Service Bulletin

Bulletin No.: 20-NA-219

Subject: Gurgle or Sloshing Noise Heard Coming from Front Sunroof Drain Hose Areas

This bulletin replaces PIT5761. Please discard PIT5761.

5677469

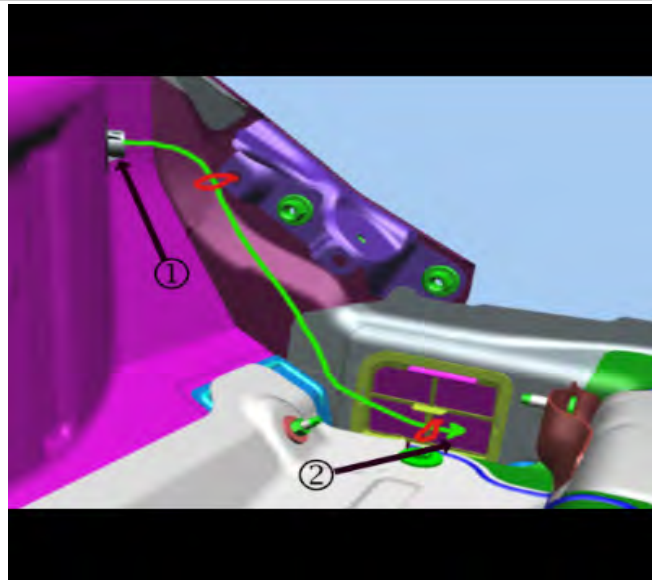
Note: An illustration of the driver side hose is shown in the graphic above.

Following the steps in the Service Procedure below, add drain hose extensions to both the right and left sides. These extension hoses will attach to the existing sunroof front drain hose grommets (1) in the plenum and then exit out the plenum drain valve (2), on that side of the vehicle.

5677473

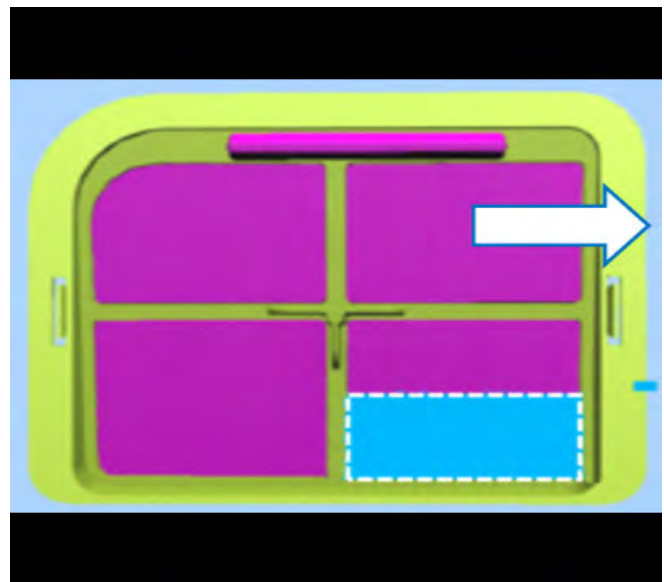
Important: Ensure that the drain hose (1) is installed perpendicular to the grommet.

4. Starting on the driver side, bond one end of the drain hose to the existing plenum grommet, using Loctite 380™ Black Max® Instant Adhesive.

5677474

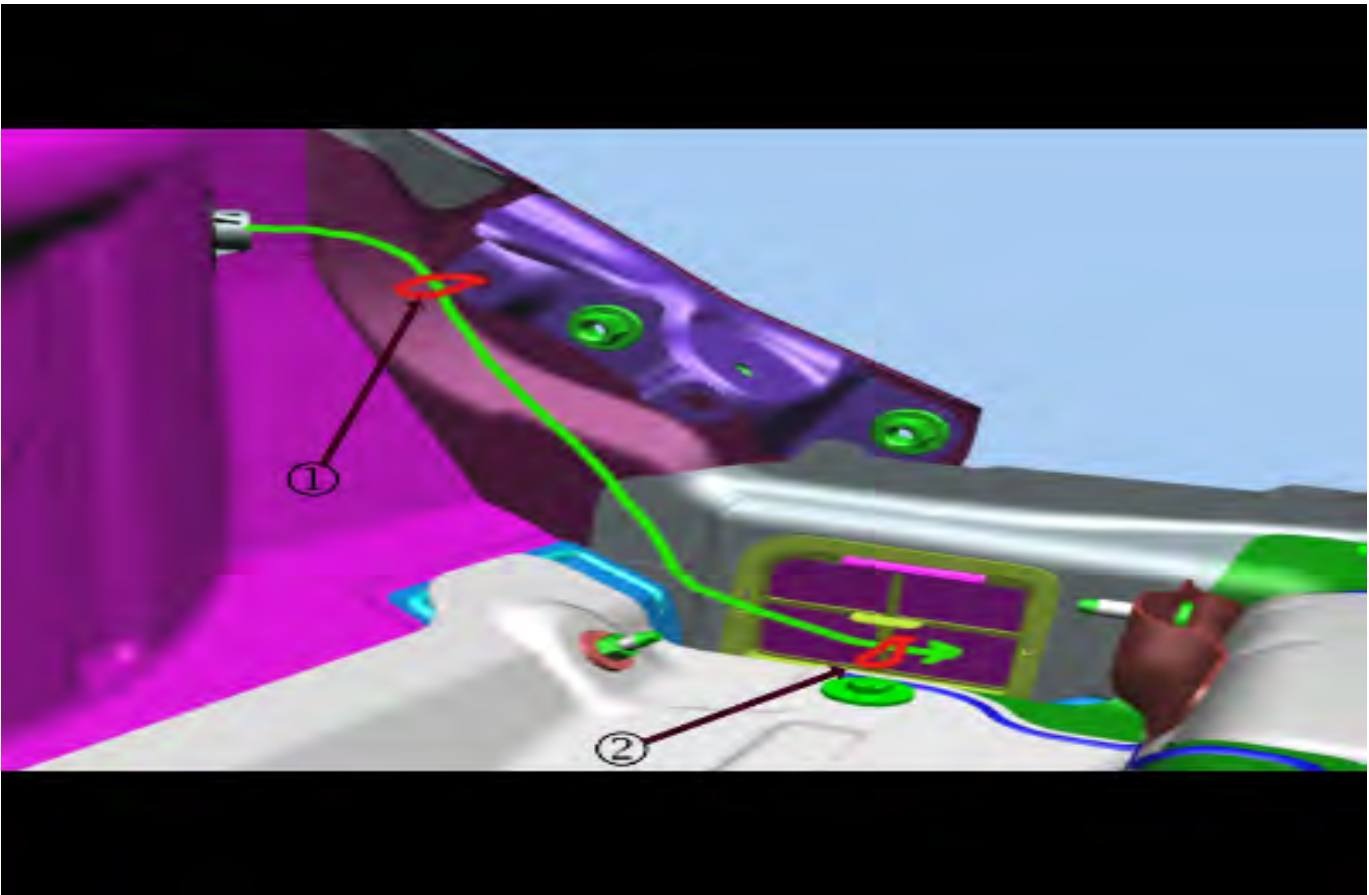
6. Using scissors, or another suitable cutting tool, cut away 1/2 of the lower, forward flap section of the valve.
7. Reinstall the plenum drain valve.

5677478

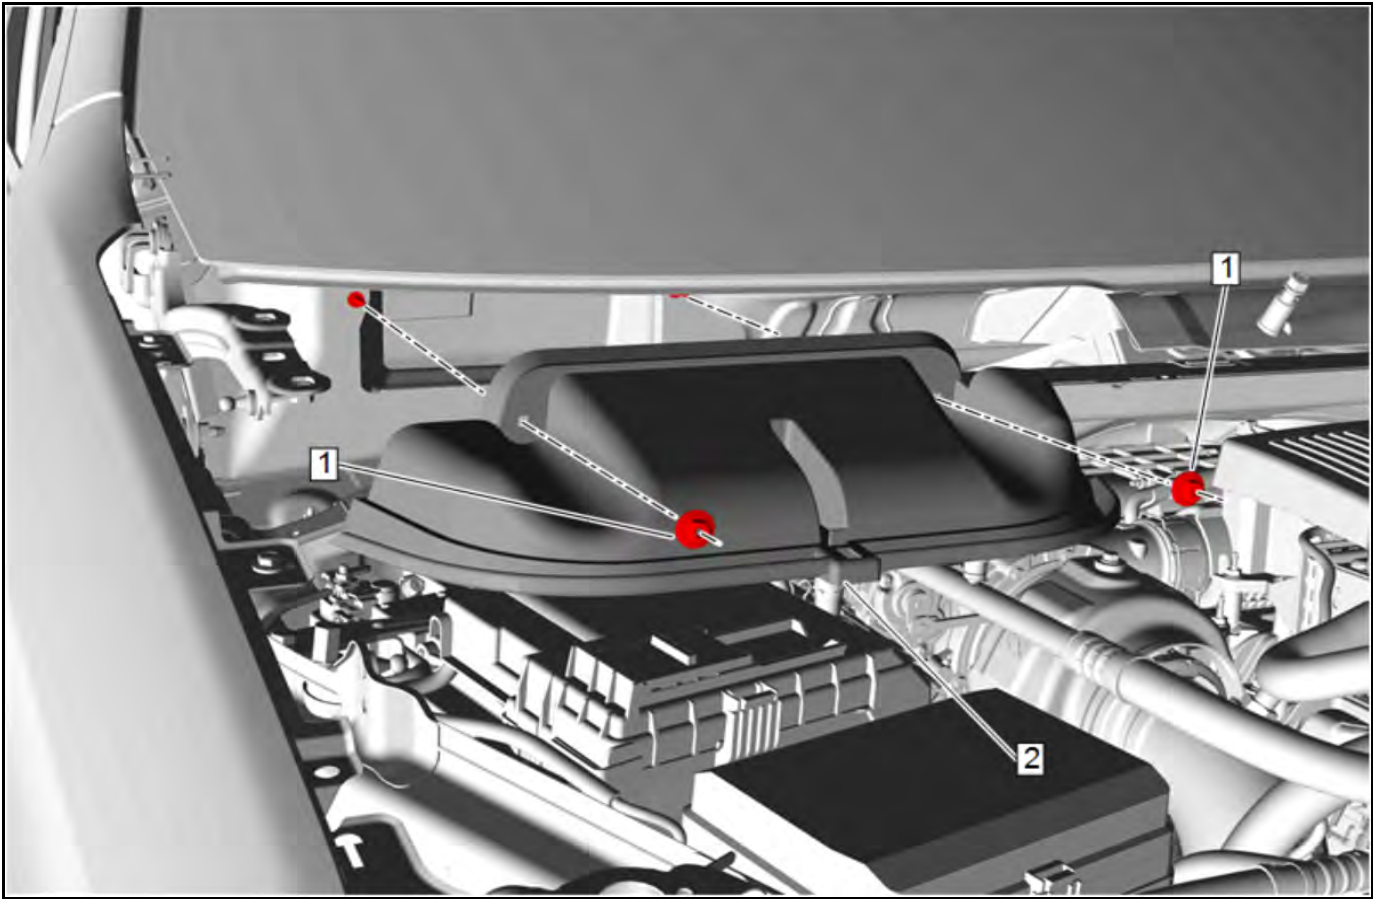
8. Using 2 tie straps, secure the drain hose to the upper open hole in the inner sheet metal bracket (1), then secure the lower end of the hose to the center support of the plenum drain valve (2).

5677480

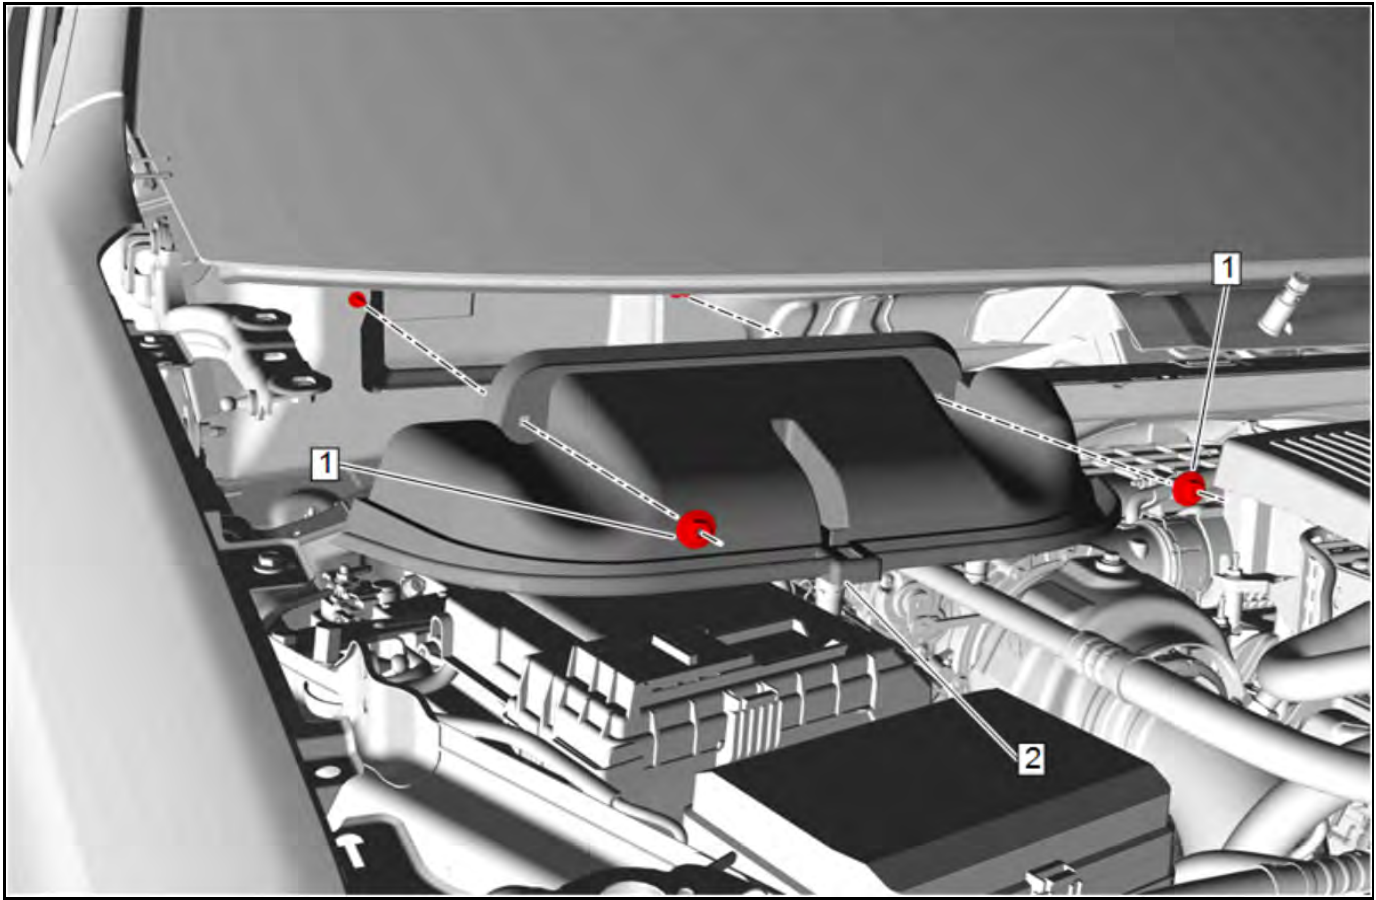
10. Repeat steps 4-8 on the passenger side of the vehicle, except for step #8. The passenger side does not have the upper sheet metal bracket, so you'll only install 1 tie strap to the plenum drain valve center support (1).

Note: The graphic above shows the hose installation completed on both the passenger and driver sides.
